**Z-21  
(2010)**

Re-Zoning Survey For:  
 Timothy F. Pilgrim

PETITION NO: Z-21

**ZONING COMMENTS:**

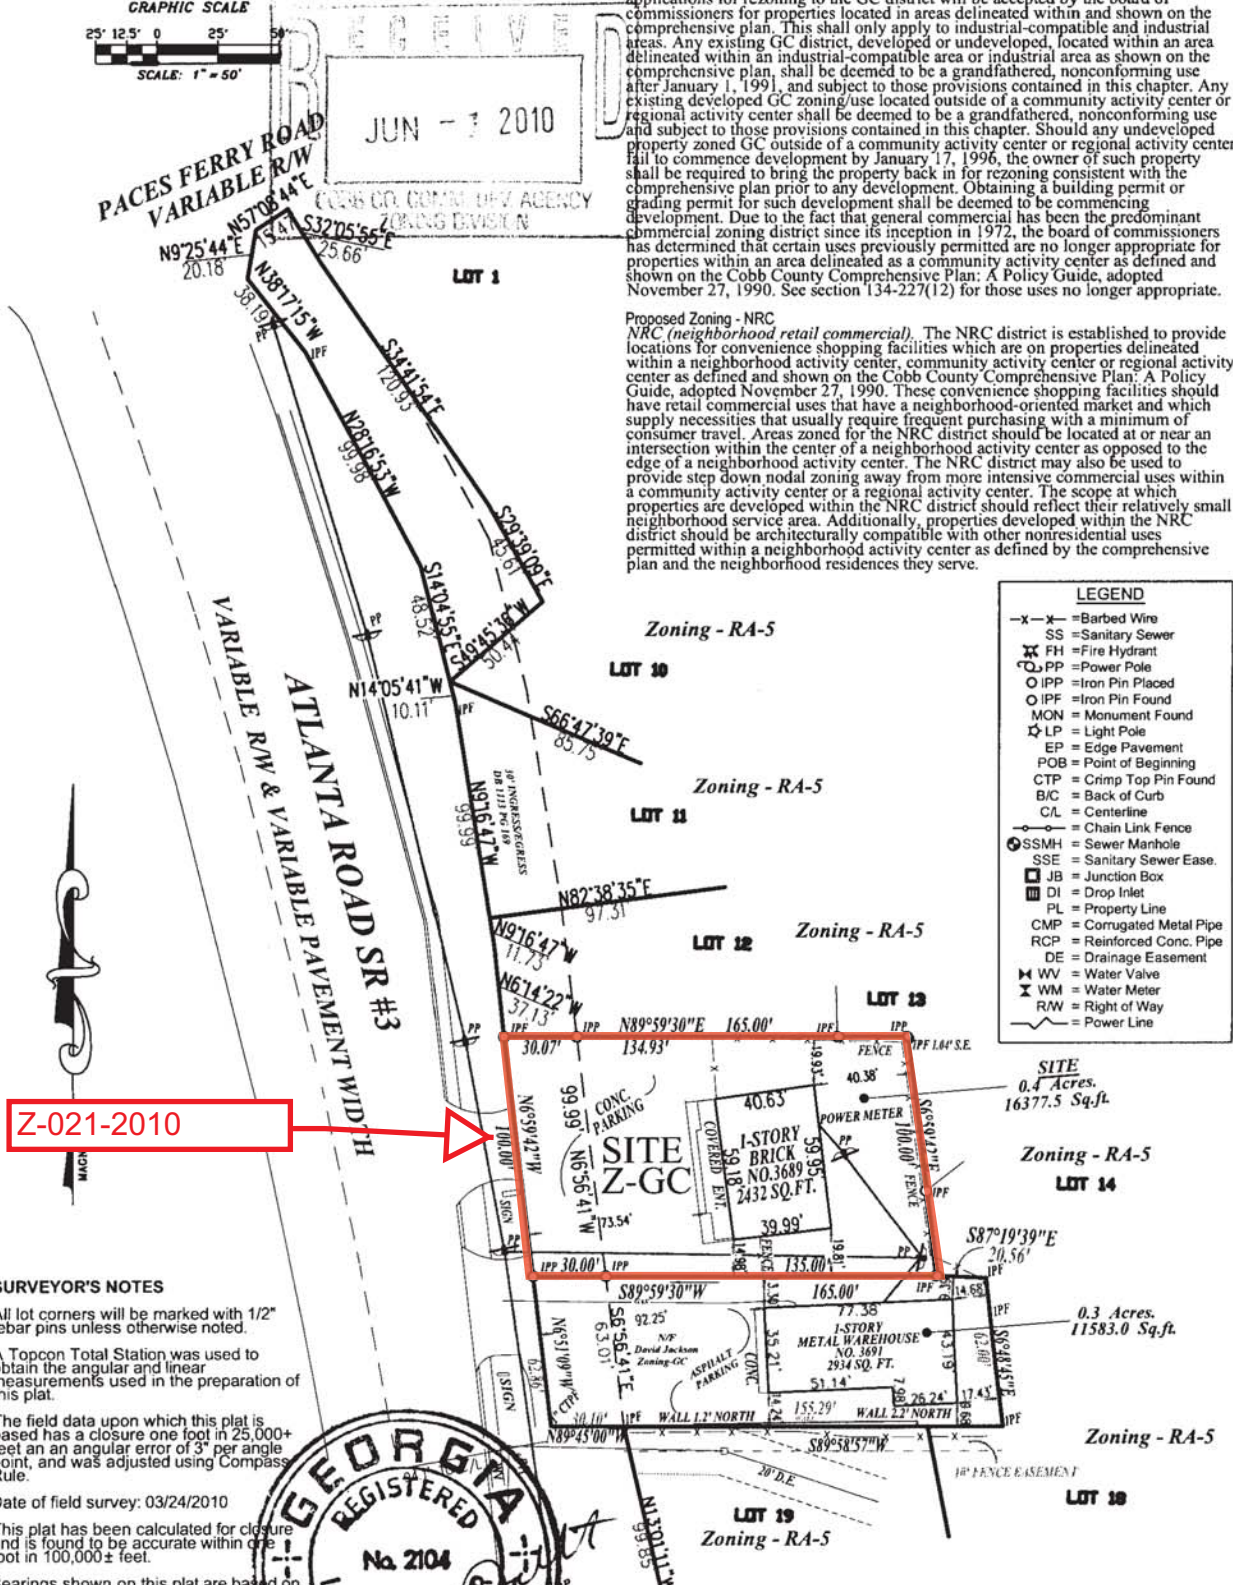
- No Stormwater controls shown \_\_\_\_\_
- Copy of survey is not current - Additional comments may be forthcoming when current site conditions are exposed.
- No site improvements showing on exhibit.

1. No site improvements are proposed at this time. It is anticipated that DOT will require removal of the parking spaces that are currently located within the Atlanta Road right-of-way. The Stormwater Management Division would support this stipulation and request that this pavement be removed to help reduce the impervious impact of the site. Any redevelopment or site improvements will require meeting the full stormwater management code requirements.
